**Proposed Residential Development at
Elmfield, Clondalkin, Dublin 22**

Stage 1 Quality Audit Report

Document Ref:	P250142-PMCE-XX-XX-RP-QA-3_0001
---------------	---------------------------------

Stage 1 Road Safety Audit

A.1.1 Lack of Tactile Paving at Crossing Points

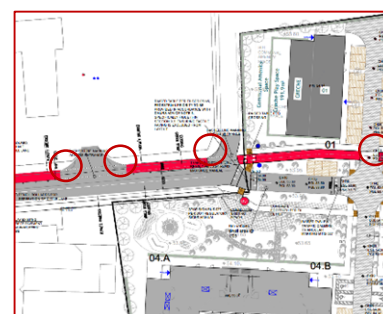
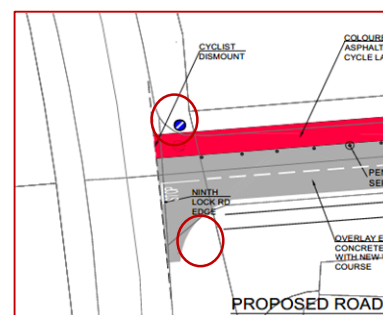
Absence of tactile paving was noted at a number of locations within the proposed development, and also within the existing road layout on Oakfield and Ninth Lock Road, including:

- No tactile paving currently provided, or indicated, at the retained dropped kerbs at the existing uncontrolled pedestrian crossing across Oakfield at its junction with Ninth Lock Road.
- No tactile paving currently provided, or indicated, at the retained dropped kerbs at the existing uncontrolled pedestrian crossings across the vehicle accesses on either side of Oakfield

The absence of tactile paving at these existing locations, and within the proposed development, may create difficulties for visually impaired, or partially sighted, pedestrians in identifying the crossing points and understanding the road layout.

Appropriate tactile paving should be provided at the retained dropped kerbs at the existing uncontrolled pedestrian crossings on Oakfield, and along pedestrian desire lines within the proposed development, where not currently indicated.

A.1.2 Delineation between Home Zone Areas and Carriageway

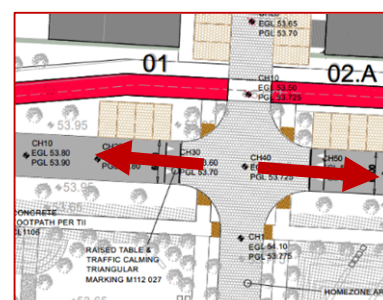
It is unclear if any delineation would be provided between the Home Zone carriageways within the proposed development and carriageways for vehicular use only. A lack of clear delineation between Home Zones and other primarily vehicle-occupied areas within the development may lead to a risk of visually impaired pedestrians inadvertently entering the adjacent carriageway from the Home Zone.

Measures should be provided at transitions between Home Zone carriageways and adjacent carriageways to clearly advise visually impaired pedestrians of the transition between the different surfaces.

A.1.3 Parked Vehicles Encroaching into Footpaths

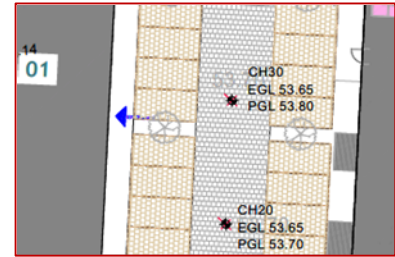
Footpaths adjacent to perpendicular parking spaces appear to be narrow in some locations. Should vehicles parked within these parking spaces overhang the adjacent footpath it may decrease the effective width of the footpath below sufficient levels, which may lead to difficulties for visually and mobility impaired road users, particularly wheelchair users, when travelling on the footpath.

Measures should be provided to prevent parked vehicles from significantly encroaching into the adjacent footpath.

A.1.4 Pedestrian Priority at Development Access

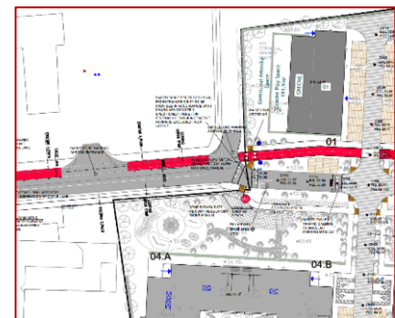
A note on the drawing indicates that the pedestrian crossing across the access road to the proposed development is to include pedestrian priority suggesting that either a continuous footpath or Zebra crossing would be provided. The layout proposed does not indicate either of these types of arrangements, and suggests that an uncontrolled pedestrian crossing would be provided.

If road user priority is not clear from the road layout it may lead to confusion for road users regarding who has priority at the crossing, leading to difficulties for visually impaired pedestrians, in particular, in independently navigating the road layout.

The layout of the proposed crossing at this location should clearly convey the intended priority at the crossing to all road users, and be easily understood by visually impaired pedestrians.

A.1.5 Tactile Paving Arrangement at Cycle Track Crossing

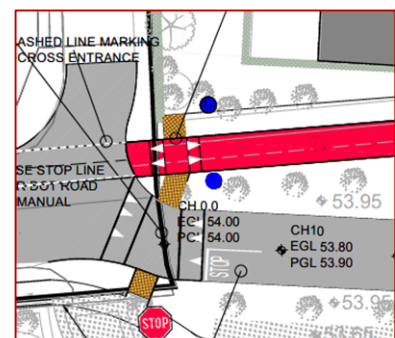
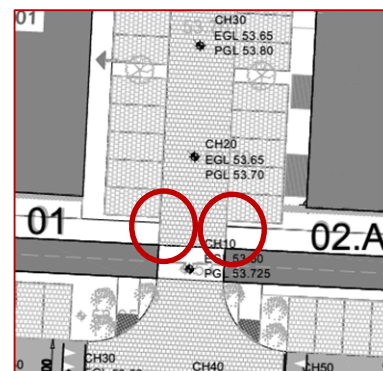
A raised cycle track crossing and raised carriageway crossing are proposed adjacent to each other at the access to the proposed development. The tactile paving on the southern side of the cycle track crossing is indicated as connecting with the tactile paving on the northern side of the raised carriageway crossing, such that it is laid across the full length of this short footpath link. The tactile paving layout on the southern side of the carriageway crossing also does not align with the tactile paving at the crossing across the cycle track. In addition, the tactile paving on the northern side of the cycle track crossing is indicated across the full depth of the footpath.

The tactile paving layout at both of these crossings may lead to confusion for visually impaired pedestrians resulting in them being unable to safely and independently navigate the road layout.

The tactile paving layouts on both sides of these crossings should be revised to provide a gap between the tactile paving at each crossing, to remove the tactile paving from the full depth of the footpath on the northern side of the cycle track and to ensure the tactile paving on both sides of the carriageway crossing are sufficiently aligned.

A.1.7 Access to/from Accessible Parking Spaces

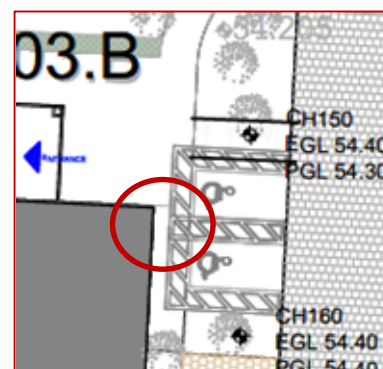
There are a number of accessible parking spaces indicated within the Home Zones in the proposed development. It is unclear if the accessible parking spaces within the Home Zones are level with the adjacent footpath and, if a level difference is provided, mobility impaired vehicle occupants may experience difficulties travelling between the footpath and their vehicle.

However, if a level difference is intended between the parking spaces and footpath, no dropped kerbs and tactile paving have been indicated at the accessible parking spaces to advise visually impaired pedestrians of the transition between the footpath and parking space/carriageway.

If a level difference is being proposed, ensure dropped kerbs and tactile paving are provided at the accessible parking spaces.

A.1.8 Pedestrian Crossing Desire Lines

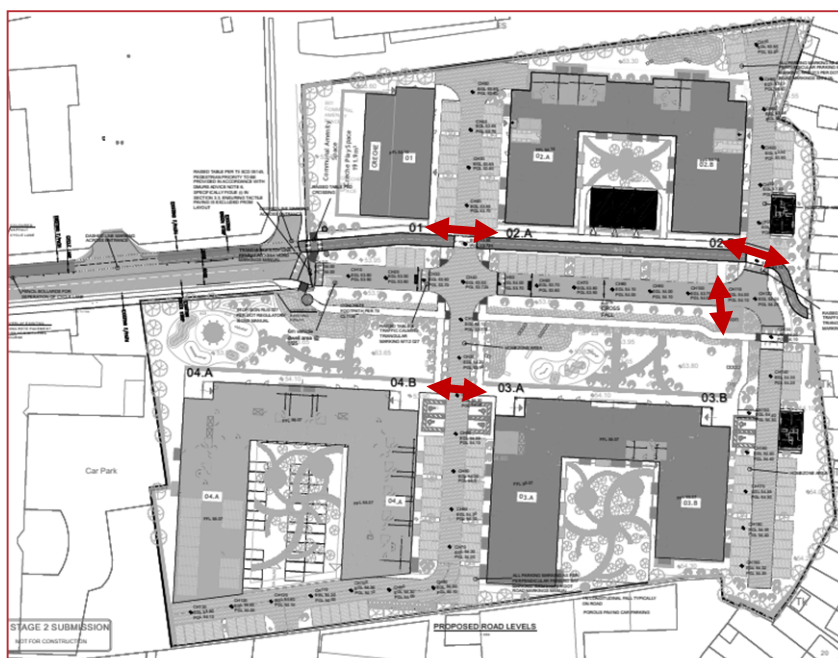
A failure to provide pedestrian crossings along likely pedestrian desire lines, including where these are across the proposed cycle track, may lead to difficulties for the visually and mobility impaired, particularly wheelchair users, when crossing the carriageway or cycle track.

During the design development, an assessment should be undertaken of the likely non-motorised road user desire lines and associated road/cycle track crossings. Pedestrian crossings, including dropped kerbs and tactile paving, should be provided at appropriate locations to support the identified desire lines.

A.1.13 Access to/from Parking Spaces

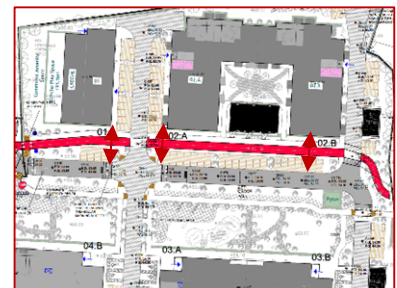
A cycle track is indicated running through the proposed development in an east to west direction. There are a number of pedestrian desire lines across the cycle track between the parking spaces on the southern side of the cycle track and the footpath on the northern side of the cycle track which are not catered for with a crossing. Absence of crossings across the cycle track at these pedestrian desire lines may lead to mobility impaired vehicle occupants, parked on the southern side of the cycle track, being unable to safely and independently cross the cycle track to access the footpath.

Provide additional cycle track crossings on pedestrian desire lines.

B.1.2 Tree Canopies

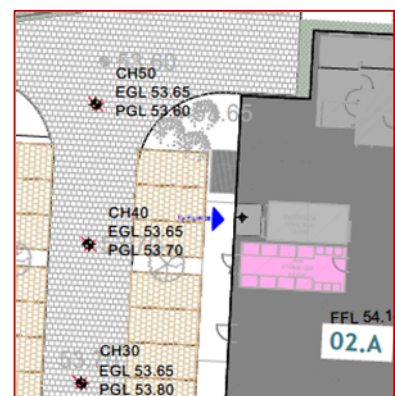
Trees have been indicated at the edge of the footpaths throughout the proposed development. A minimum clear stem of 1.5m for trees within the development has been indicated. This clearance beneath tree canopies would be insufficient for trees that overhang footpaths. Low hanging tree canopies may impede pedestrians travelling on the footpaths, resulting in a risk of head strikes and personal injury.

Trees adjacent to, or overhanging, the footpath should have a vertical clearance of 2.3m to the footpath.

B.1.3 Connection between Home Zone and Footpath

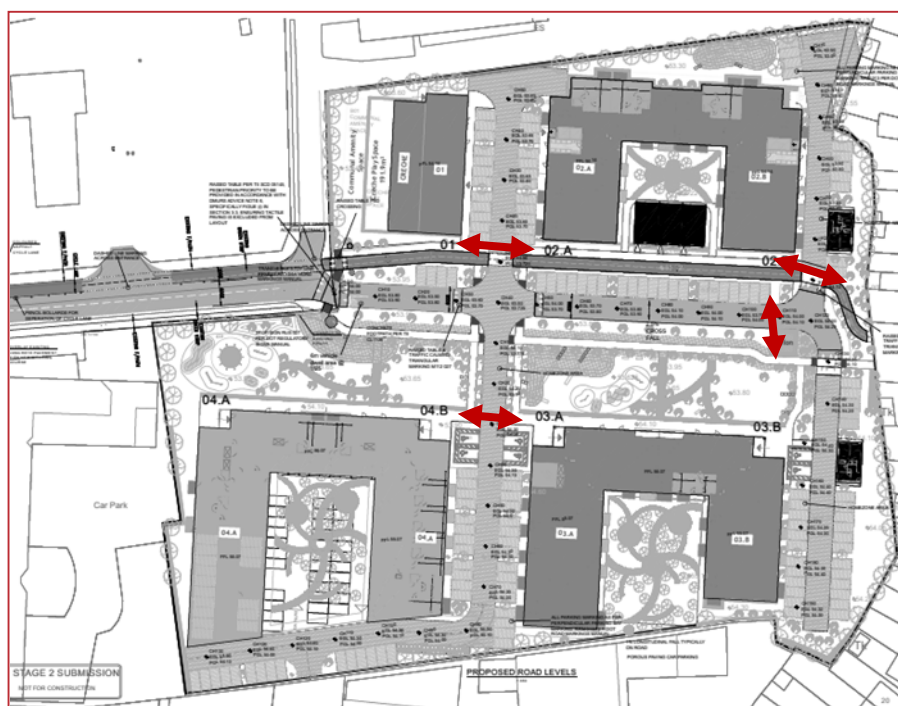
Home Zones have been indicated throughout the proposed development. It is unclear how pedestrians would access the footpath on both sides of the Home Zone carriageway in some of these Home Zones as there is a verge indicated between the footpath and the Home Zone carriageway. A verge separating the footpath and Home Zone carriageway would present a barrier for pedestrians when accessing the footpath, leading to them either trying to cross the verge to access the footpath or having to travel longer distances to a suitable access.

Clear and accessible connections should be provided between the Home Zone carriageways and the adjacent footpaths.

B.1.4 Pedestrian Crossing Desire Lines

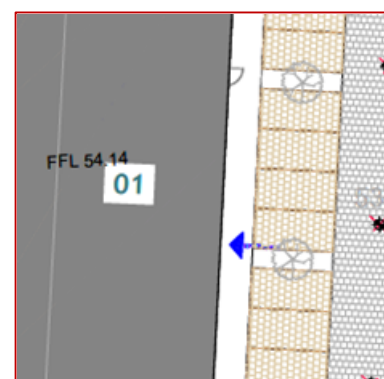
There is likely to be a number of pedestrian desire lines within the proposed development, including between the residential units and the areas of open space and across side roads at the development's internal junctions.

A failure to provide pedestrian crossings along likely pedestrian desire lines, including where these are across the proposed cycle track, may lead to pedestrians having to ascend/descend high kerbs when crossing the carriageway or cycle track.

During the design development, an assessment should be undertaken of the likely non-motorised road user desire lines and associated road/cycle track crossings. Pedestrian crossings, including dropped kerbs and tactile paving, should be provided at appropriate locations to support the identified desire lines.

B.1.6 On-Street Parking on Oakfield

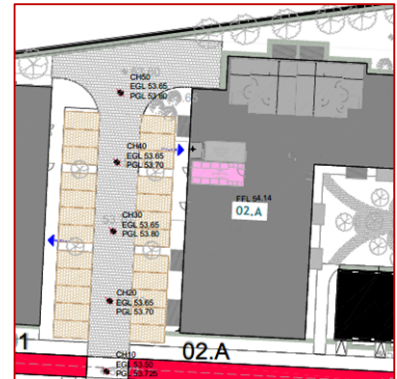
During the site visit, a number of vehicles were noted parked within, or partially within, the footpath on the southern side of Oakfield. On-street parking within the footpath at this location may force pedestrians to travel within the carriageway to avoid the parked vehicles.

Provide measures to deter parking within the footpath on the southern side of Oakfield.

C.1.2 Layout of Cycle Track

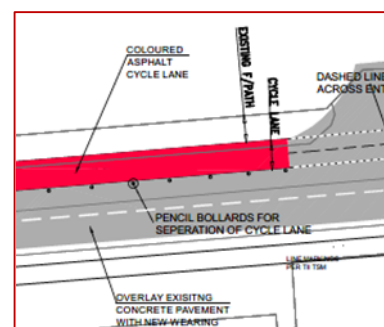
A 3m wide cycle track is indicated running through the development in an east to west direction. It is unclear, however, if the cycle track is proposed to be a one-way, or two-way, cycle track. The lack of definition of the cycle facility may lead to confusion for cyclists regarding the operation of the cycle track.

In addition, if a two-way cycle track is proposed, the proposed width of the cycle track may not accommodate the volume of cyclists using it.

The cycle track should be of a sufficient width, and clearly marked, for its intended layout, and operation, and should be designed in accordance with the Cycle Design Manual.

Access control at its tie-in with Ninth Lock Road should be considered also if it is proposed that the cycle track is two-way.

C.1.4 Termination of Cycle Track

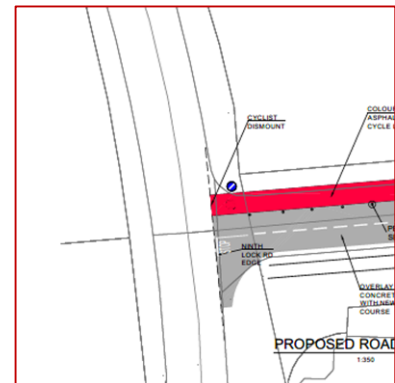
The cycle track indicated along the northern side of Oakfield is indicated terminating at the junction with Ninth Lock Road, where it is unclear how cyclists would navigate between the Ninth Lock Road carriageway and the cycle track, particularly in the case of westbound and northbound cyclists on Ninth Lock Road who would have to cross the carriageway to turn onto, or off, the cycle track.

In addition, it is unclear how the cycle track will tie in with the adjacent development at its eastern end. There is a concern that eastbound cyclists may have to continue their journey within the adjacent grassed area, which may present loss of traction, and bicycle control, issues for cyclists.

A clear, safe route should be provided for cyclists entering/leaving the cycle track at each end.

3.1 Cycle Lane Surface Colour Across Accesses

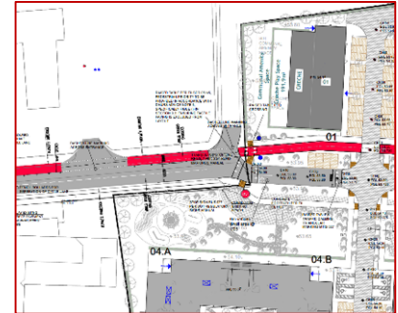
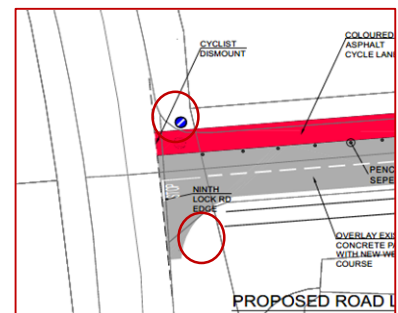
Provide sufficient coloured surfacing within the cycle lane where it crosses accesses.

3.2 Lack of Tactile Paving

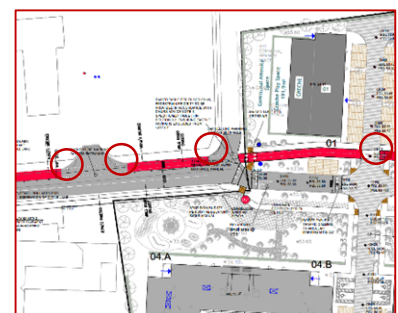
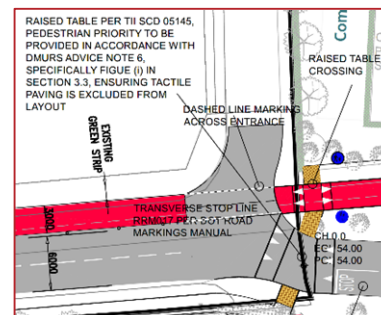
The existing footpaths on both sides of Oakfield are indicated as being retained however the dropped kerbs on both sides of the existing accesses on this road do not currently include tactile paving, nor is any indicated as part of the proposed scheme. There is also no tactile paving provided across the Oakfield/Ninth Lock Rd Junction. A failure to provide tactile paving at road/access crossings on the existing pedestrian desire lines may lead to visually impaired pedestrians inadvertently entering the carriageway, increasing the risk of vehicle-pedestrian collisions.

There is also a likely pedestrian desire line across the northern arm of the crossroad junction, within the proposed development, where no tactile paving has been indicated. An absence of tactile paving at road crossings within the development may lead to visually impaired pedestrians being insufficiently aware they are entering a Home Zone, increasing the risk of collisions with other road users.

In addition, no tactile paving has been indicated where the carriageway transitions to Home Zone carriageways throughout the development. An absence of tactile paving at these transitions may lead to visually impaired pedestrians being insufficiently aware that they are entering a Home Zone, increasing the risk of a collisions with other road users.

Provide tactile paving at road/access crossings on pedestrian desire lines and at the transitions to the proposed Home Zone carriageways within the development.

3.3 Incorrect Crossing Layout

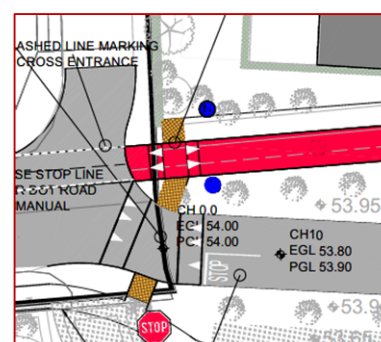
A note on the drawing indicates that the pedestrian crossing across the access road to the proposed development is to include pedestrian priority suggesting that either a continuous footpath or Zebra crossing would be provided. The layout proposed does not indicate either of these types of arrangements, and suggests that an uncontrolled pedestrian crossing would be provided.

The layout of the proposed crossing at this location should clear convey the intended priority at the crossing to all road users.

3.3	Yes	Yes	Updated note added, crossing as per TII 05145, DMURS Note 6 Figure ii	
3.4	Yes	Yes	N/A	
3.5	Yes	Yes	N/A	
3.6	No	No	The footpath width provided is 1.5m. Vehicle stops have been provided in the parking spaces to avoid overhang	Yes

3.4 Alignment of Pedestrian Crossing & Tactile Paving Layout

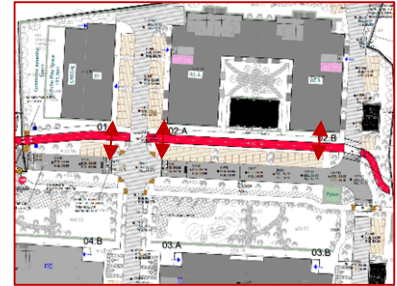
The tactile paving layouts on both sides of these crossings should be revised to provide a gap between the tactile paving at each crossing, to remove the tactile paving from the full depth of the footpath on the northern side of the cycle track and to ensure the tactile paving on both sides of the carriageway crossing are sufficiently aligned.

3.7 Home Zones

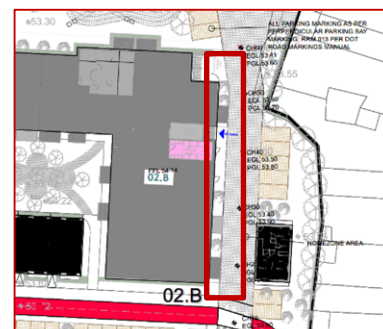
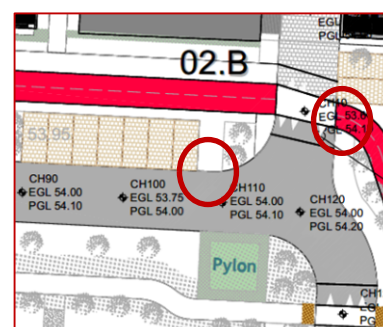
Summary: *It is unclear if safe zones for visually impaired pedestrians would be provided within the Home Zones, and there are obstructions indicated within the footpath at the edge of the Home Zone carriageways which may lead to pedestrians being unable to step off the carriageway to avoid cyclists or motorised vehicles.*

Provide a segregated safe zone within the Home Zones in the proposed development, free from any obstructions.

3.8 Footpath Termination

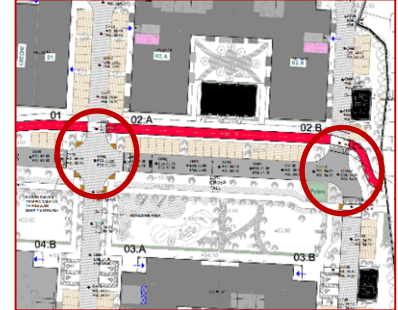
Ensure adequate footpath terminations are provided throughout the scheme.

3.8	Yes	Yes	Footpath intended to provide access to parked cars 125mm kerb at footpath termination.

Location: Drawing No. GK25126_C100 (Rev. PL1)

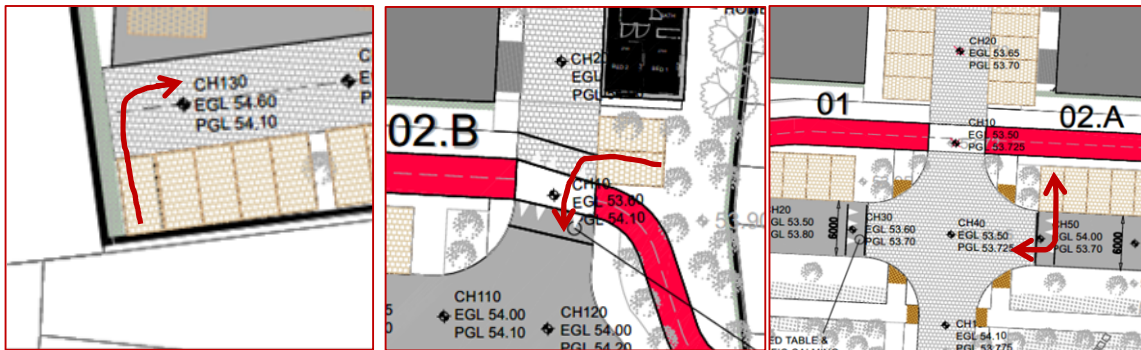
Summary: *It is unclear if drivers will be able to safely enter/exit the proposed parking spaces adjacent the raised junctions within the development, and at the westernmost parking space to the south of Apartment Block 04.A.*

It is unclear if drivers will be able to safely enter/exit the proposed parking spaces adjacent the raised junctions within the proposed development, and at the westernmost parking space to the south of Apartment Block 04.A, due to a combination of the proximity to the boundary and the angle of the carriageway, or junction.

3.9	Yes	Yes	Crossings updated with road markings to comply. Tactile paving updated along with road markings.	
3.10	Yes	Yes	Refer to revised autotrack illustrating parking compliance.

Location: Drawing No. GK25126_C100 (Rev. PL1)

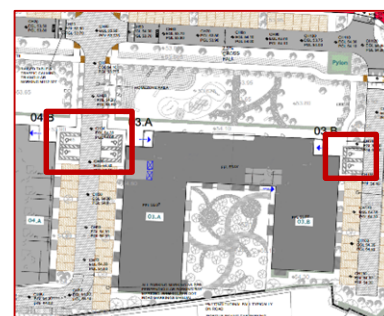
Turning heads should be provided at the ends of all cul de sacs within the proposed development. The shape and size of these turning heads should be sufficient to allow all vehicles to turn safely within the carriageway extents, and should be determined via a swept path analysis.

3.11	Yes	Yes	Turning heads added.	
3.12	No	No	There is no level difference with the homezone apart from 25mm step.	Yes
3.13	Yes	No	A new crossing point has been added just north of the disabled parking between Blocks 04B and 03A. This along with the crossing point just south of the internal link road offers direct access onto the internal footpath within the green space. The two entry points allow pedestrians to move to the internal footpath. The verge with its tree planting acts as a visual border separating the internal pedestrian footpath from the mixed traffic homezone thereby encouraging foot traffic to move within the internal footpaths.	Yes

3.12 Accessible Parking Spaces

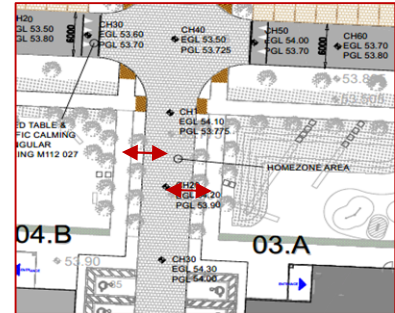
If a level difference is being proposed, ensure dropped kerbs and tactile paving are provided at the accessible parking spaces.

3.13 Access to Footpath from Homezone

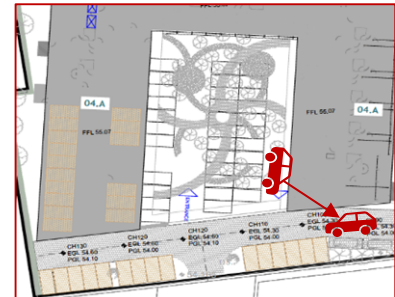
Remove the verges which separate the footpath from the Home Zone carriageway.

Location: Drawing No. GK25126_C100 (Rev. PL1) & GK25126_C101 (Rev. PL1)

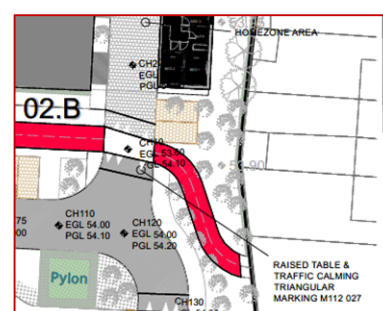
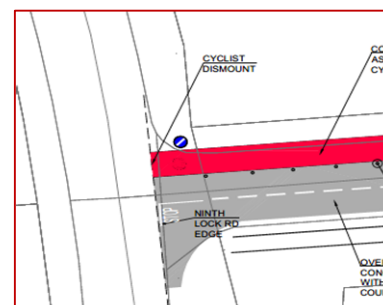
Summary: *Insufficient definition of the cycle track at its tie-ins with the existing road layout/adjacent developments may lead to cyclist confusion, resulting in a risk of collisions.*

Provide a well-defined cycle track, with sufficient width throughout its full length, that ties-in safely with the existing road layout on Ninth Lock Road.

3.14	Yes	Yes	Refer to revised sightlines lines for visibility of cars exiting the parking.	
3.15	No	No	3m cycle track width complies with the cycle design manual for two way cycling.	Yes

3.17 Tree Canopies

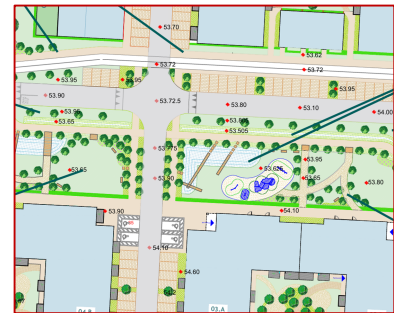
Summary: A minimum clear stem of 1.5m for street trees has been indicated within the proposed development which may impede cyclist and pedestrians travelling on the cycle track and footpaths, resulting in head strikes and personal injuries.

3.17	Yes	Yes	The landscape design intends to provide adequate clearance over all pedestrian and cycle routes. Street trees adjacent to footpaths and cycle tracks will be specified, planted and maintained to achieve a minimum clear stem height of 1.8m.

3.18 Absence of Tapers at Parallel Parking Spaces

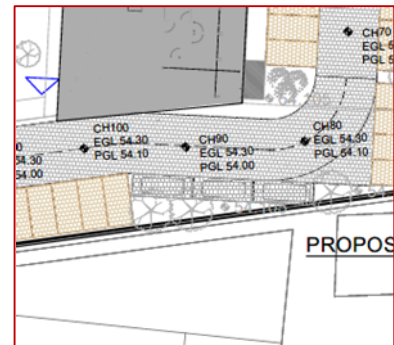
Summary: No tapers have been indicated at the ends of the parallel parking spaces which may lead to material damage collisions as drivers attempt to enter/exit these spaces.

Provide tapers at both ends of the row of parallel parking spaces.

3.18	Yes	Yes	5 x 2.5 is sufficient, refer to revised autotrack submitted.	
3.19	No	No	Sufficient sight lines per DMURS, 2m setback and 14m sightliness (20km/h HZ). Speed table and priority control junction.	Yes

Location: Drawing No. 096925_LP_01 (Rev. PL1)

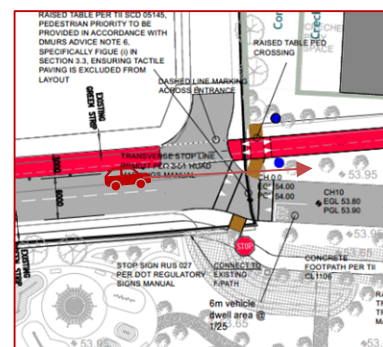
In addition, if a high-sided vehicle is parked in the parking spaces on either side of the crossroad junction, this would further restrict the inter-visibility between road users.

Ensure sufficient inter-visibility is provided between all road users approaching the crossroad junction, on all arms.

Location: Drawing No. GK25126_C100 (Rev. PL1)

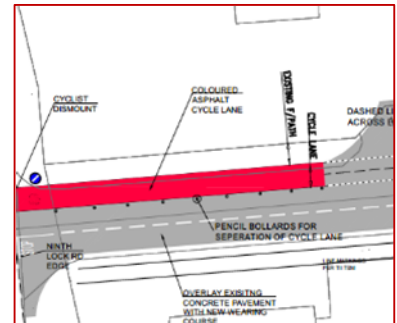
Provide measures to deter parking within the footpath on the southern side of Oakfield.
